Date Created : 2007/11/15
Date Issued On : 2007/11/29
PCN# : Q3073801-A

DESIGN/PROCESS CHANGE NOTIFICATION -- FINAL

Change Type Description: Bond Wire Material Composition, Lead Frame Dimensions (Internal and External)

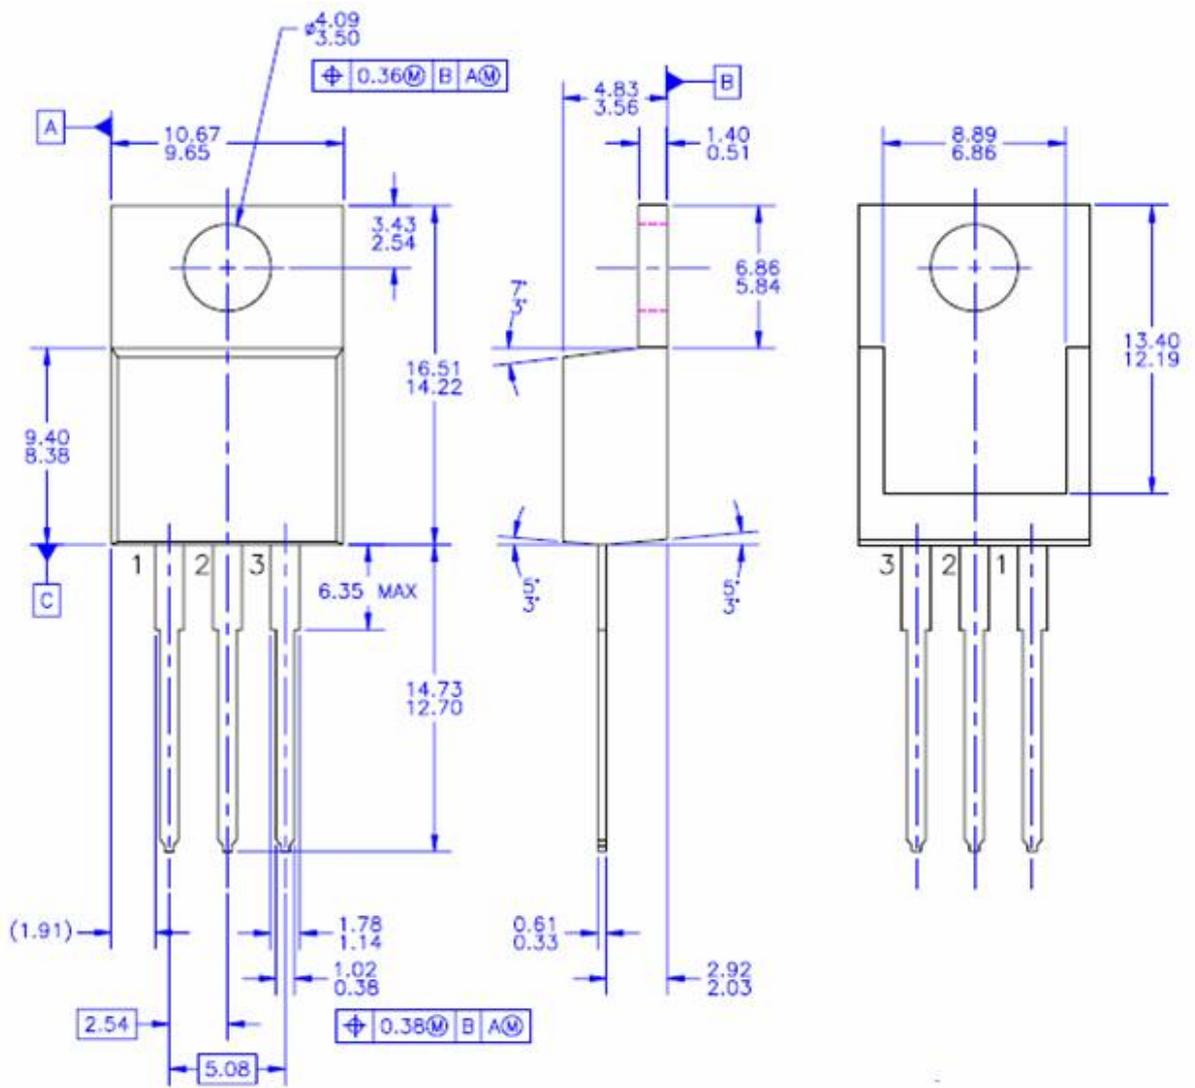
Description of Change (From): Current TO-220 heatsink and die attach pad thickness of 1.30mm. Material composition of wire used for wire bonding process is gold (Au) wire and copper (Cu) wire.

Description of Change (To): New TO-220 heatsink and die attach pad thickness will be 0.51mm. There is no change in heatsink and die attach pad material. Material composition of wire used during wire bonding process will be copper (Cu). Conversion of heatsink thickness will be done on a part by part basis starting WW05 of 2008 to prevent mixing of product with different heat sink dimensions in shipments during the transition period.

Reason for Change : Enhancement of leadframe design to improve package mechanical performance and support additional demand for various TO-220 products to improve our service to customers. There is insignificant difference in product thermal performance.
